Application No. 10/635,926  
Paper Dated: February 17, 2006  
In Reply to USPTO Correspondence of September 21, 2005  
Attorney Docket No. 964-031173

**AMENDMENTS TO THE DRAWINGS**

Application No. 10/635,926  
Amendment dated February 17, 2006  
In Reply to USPTO Correspondence of September 21, 2005  
**Annotated Sheet Showing Change**

Fig. 2

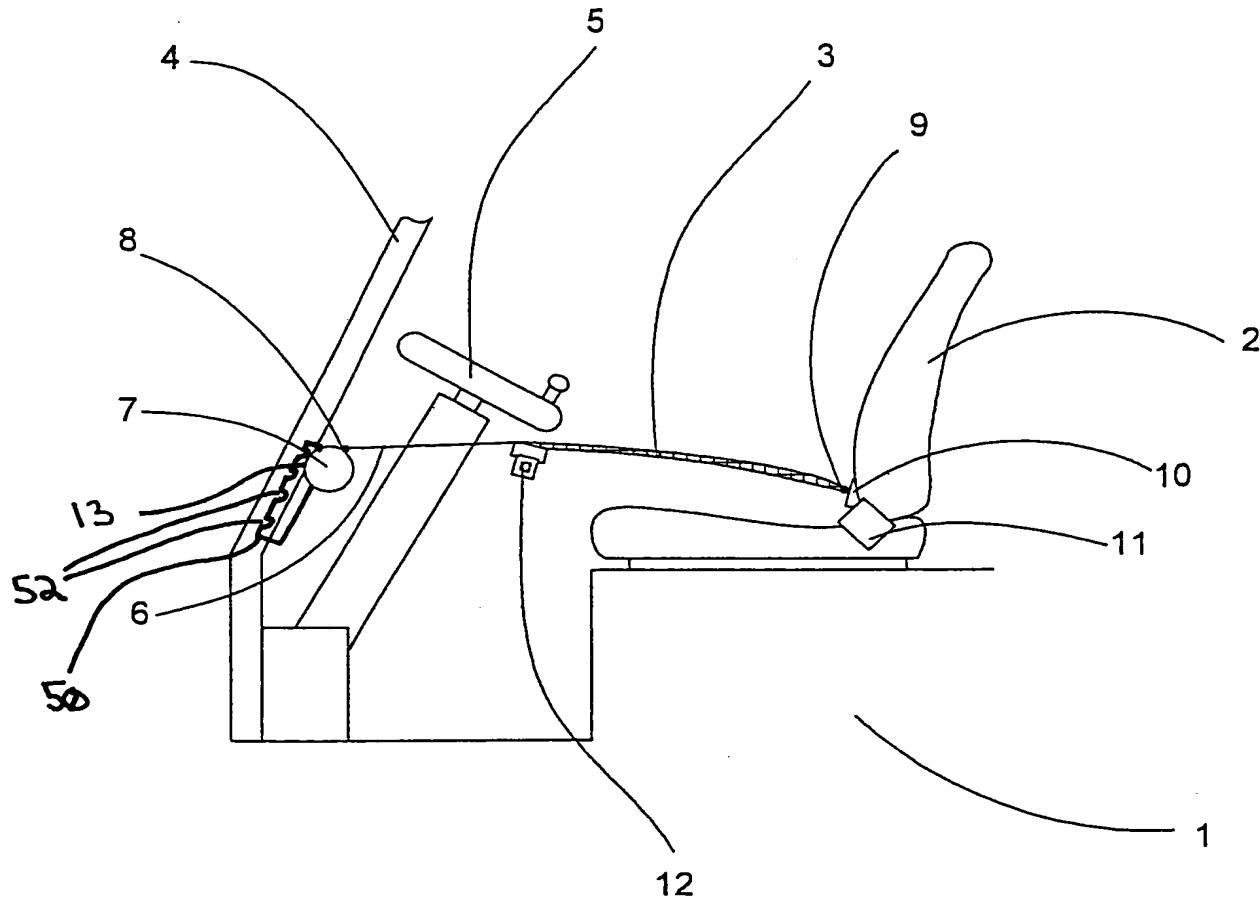
Applicant encloses herewith a proposed drawing correction to Fig. 2 showing the proposed changes in red ink. Fig. 2 has been amended to specifically show the rail and notches discussed in the specification at paragraph 0024. Approval of the proposed drawing correction to Fig. 2 is respectfully requested.

The drawings were objected to for not specifically showing the “adjustable component” claimed in claims 5, 13, 14, and 15. In response, Applicant encloses herewith a proposed drawing correction to Fig. 2 to illustrate the adjustable component. Specifically, Fig. 2 has been amended to show the rail 50 with catches or notches 52 discussed in the specification at paragraph 0024.
